ROCKWELL VILLAGE
A
PLANNED UNIT DEVELOPMENT
PUD / POADP
SAN ANTONIO, TEXAS

POADP APPLICATION

Re: Rockwell Village POADP

RE: Rockwell Village POADP

10 ACRE TAMEZ TRACT
SITE LAYOUT

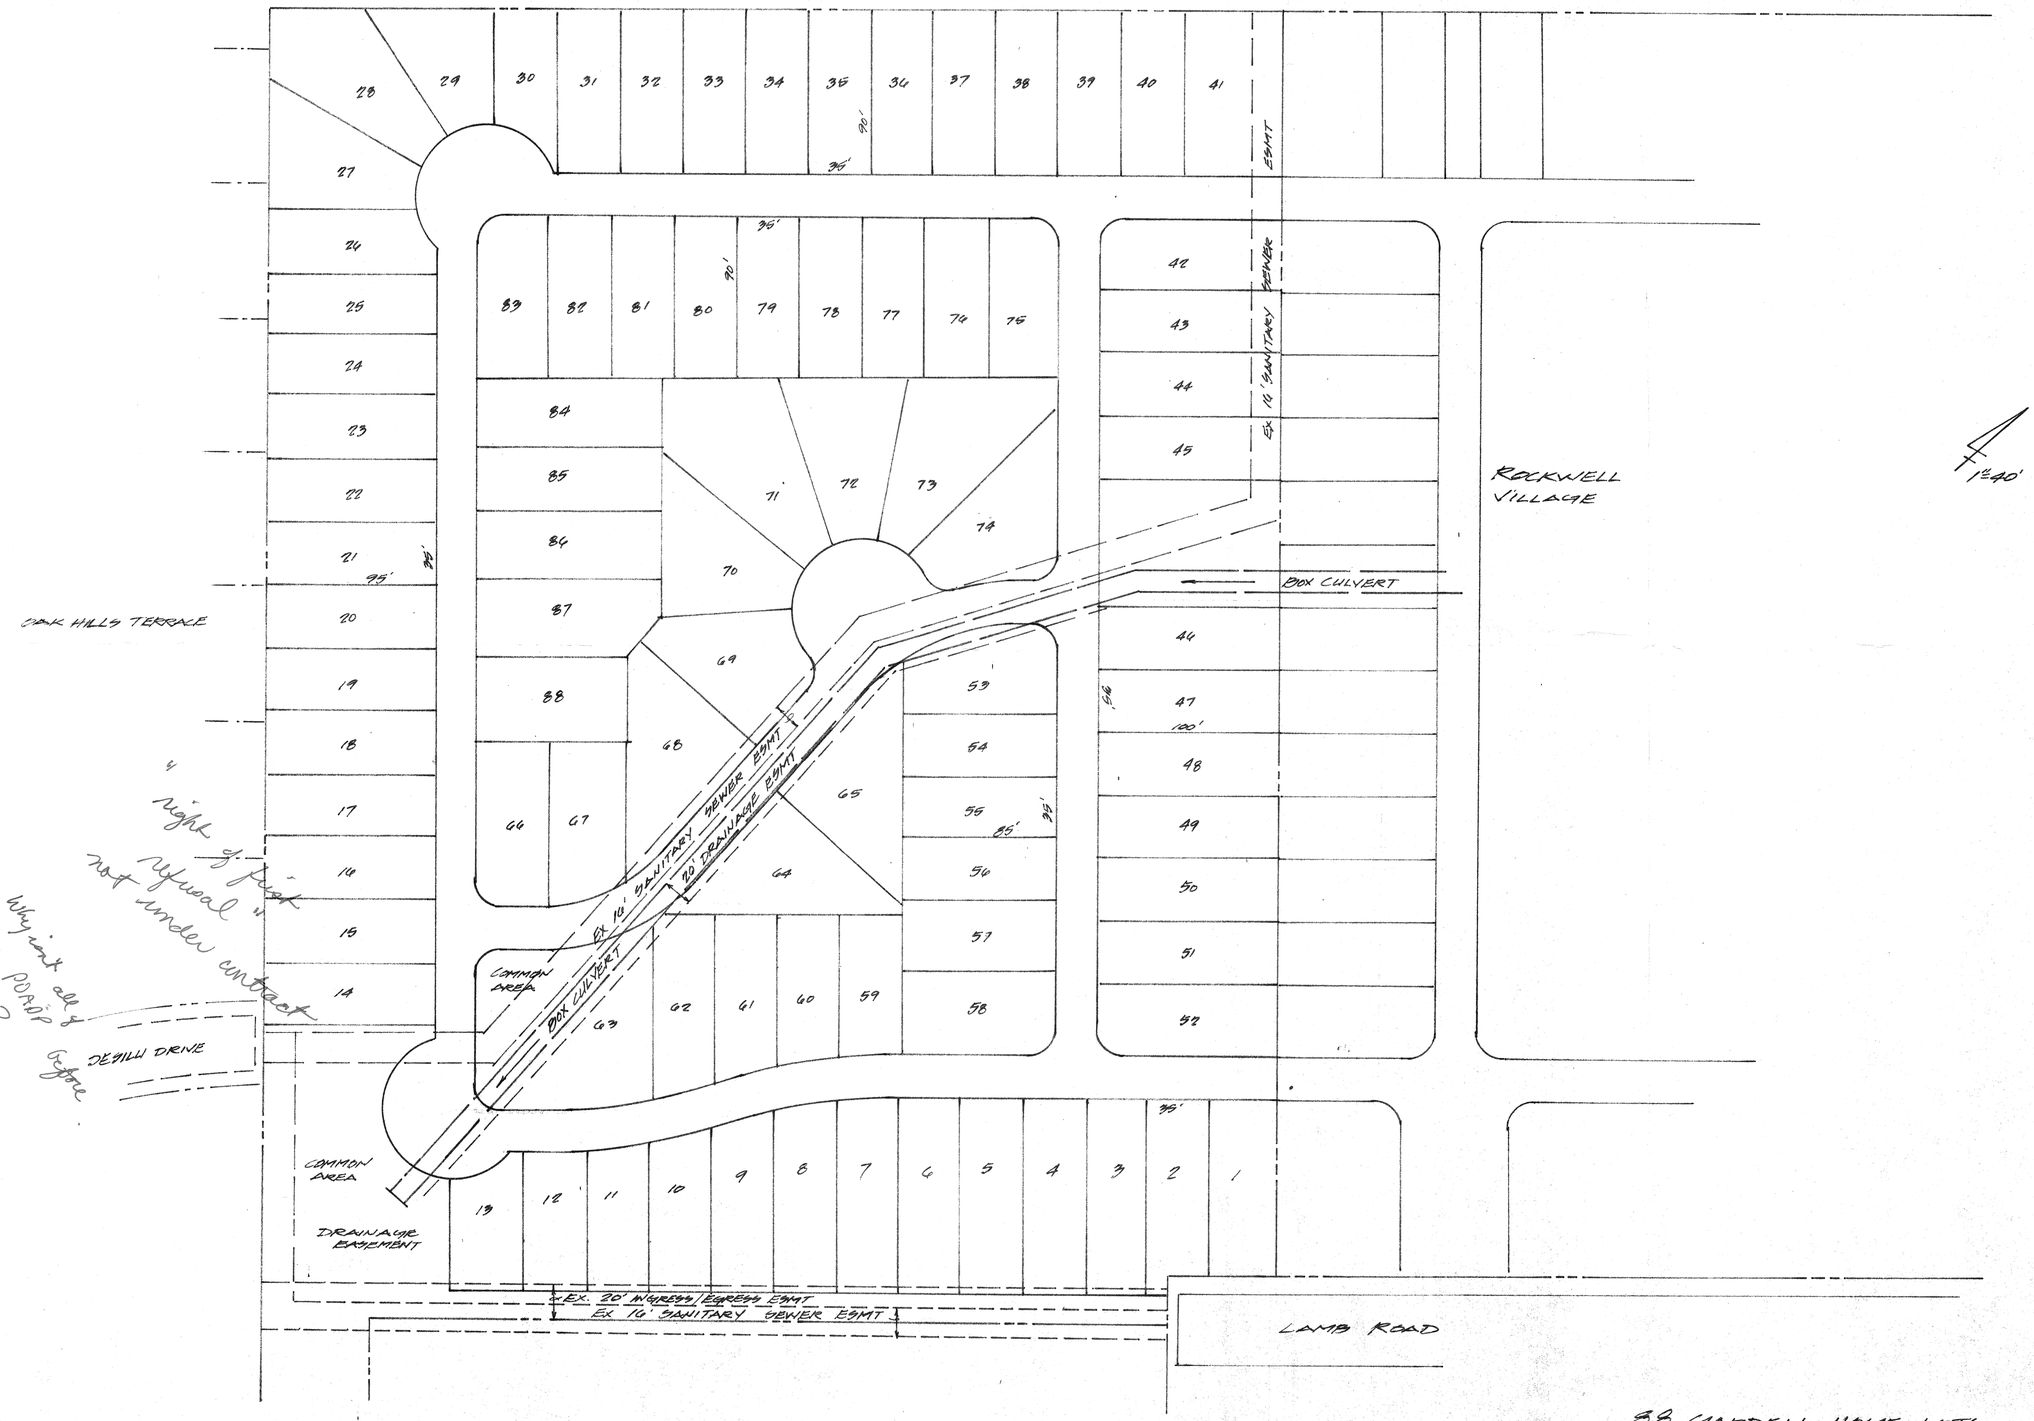
Why isn't all of this on POADP before us today?

"right of first refusal" not under contract

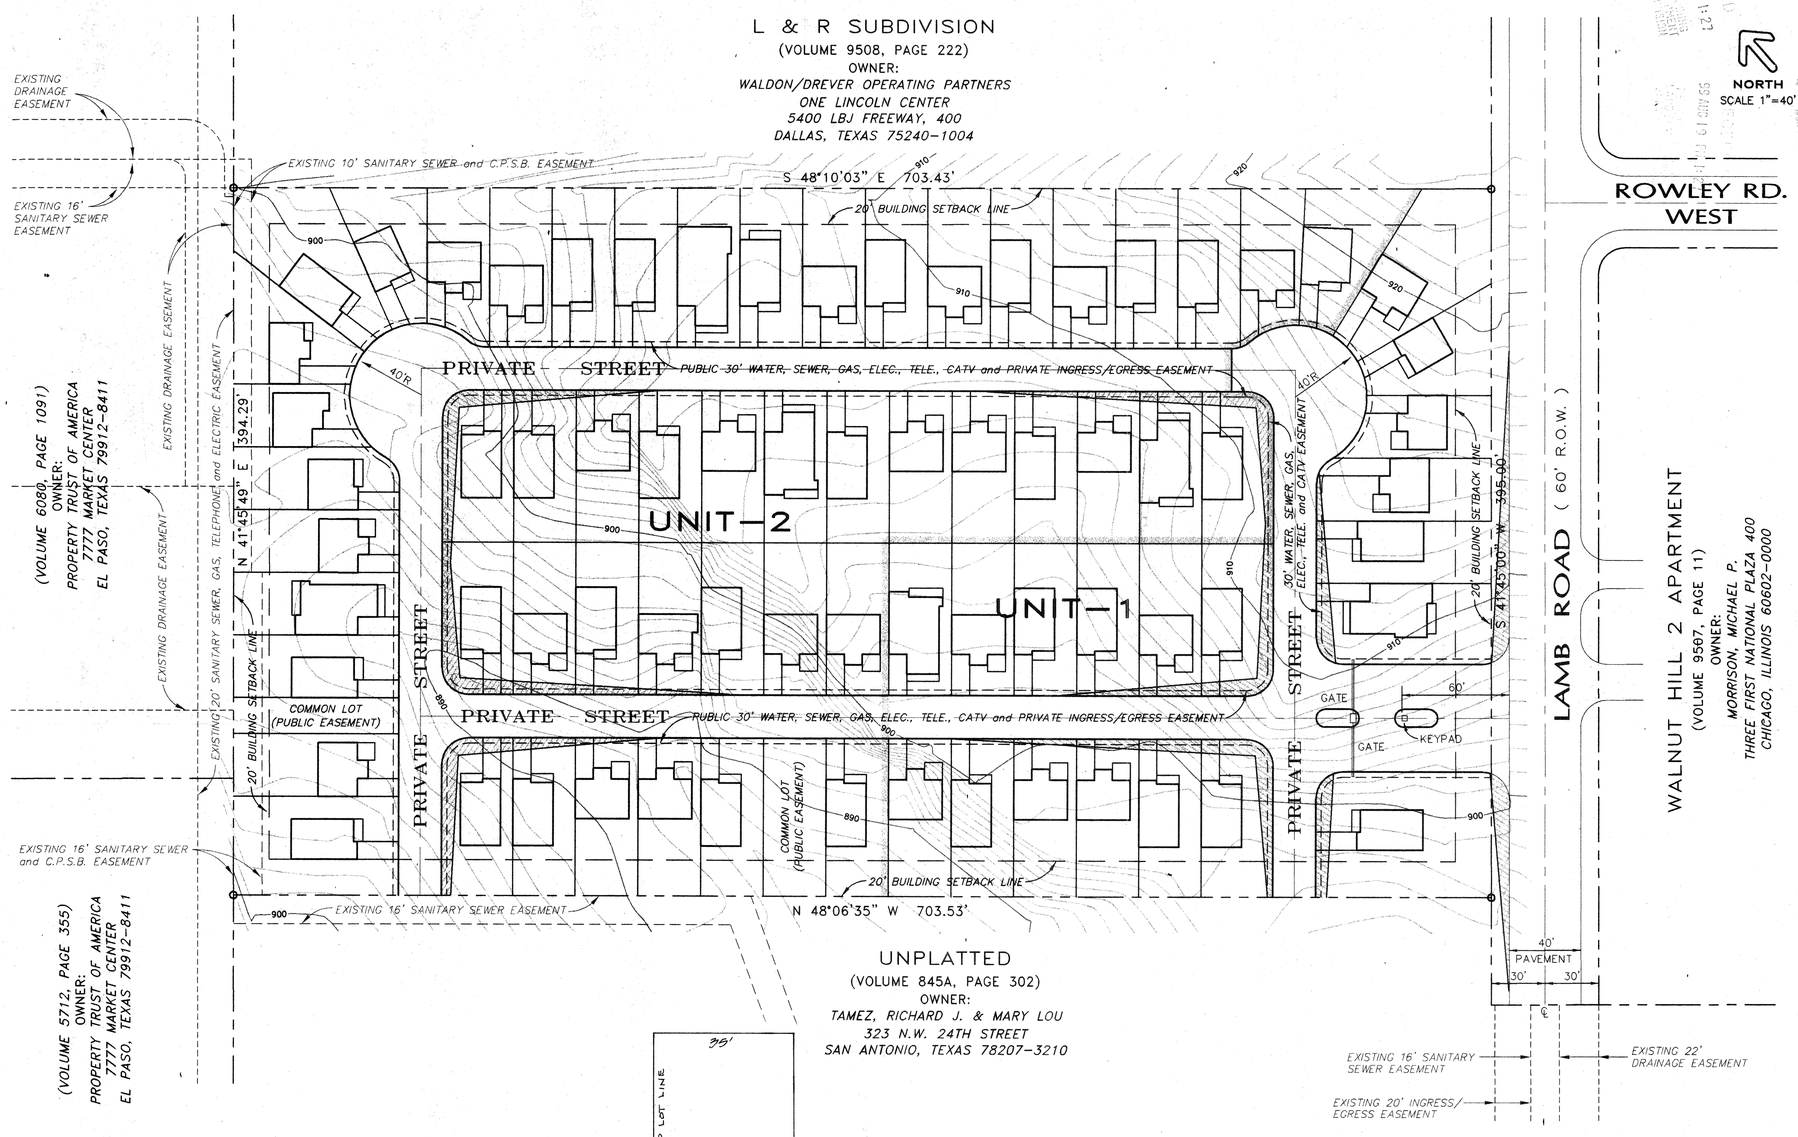
The City Staff Development Review Committee has reviewed Rockwell Village Preliminary Overall Area Development Plan # 645. Please find enclosed a signed copy for your files. Although your plan was accepted, please note the following:

- Based on the topography, a Flood Plain Study and drainage review will probably be required during the platting process.
- In consideration of public safety and convenience, excessive grades by reason of topography should be avoided in street layouts and arrangements.

- Access and R.O.W. issues along State facilities will need to be resolved with the Texas Department of Transportation (TXDOT). For information about these requirements you can contact TXDOT at 615-5814.

- This development will need to comply with tree preservation ordinance #85262. For information about these requirements you can contact Building Inspections at 207-7102.

- It will be expected that you will plat all of the property depicted in your POADP, to include: floodpains, drainage areas and open space.
- I would encourage you to work closely with the school district, so that they can plan accordingly.

- Public Works indicated that a TIA will not be required at this time due to the number of lots (77). However, a TIA may be required with future development adjacent to this site.

1. 10 side yard setback: there is no side yard setback requirement for a PUD (sec 35-3114 of the UDC)

2. Road stubout to adjacent property: attached is a tentative (conceptual) development plan for the adjacent property. (sec 35-4106)

3. TIA: submitted with the PUD/POADP

4. Slope note: I am not aware of a specific note.
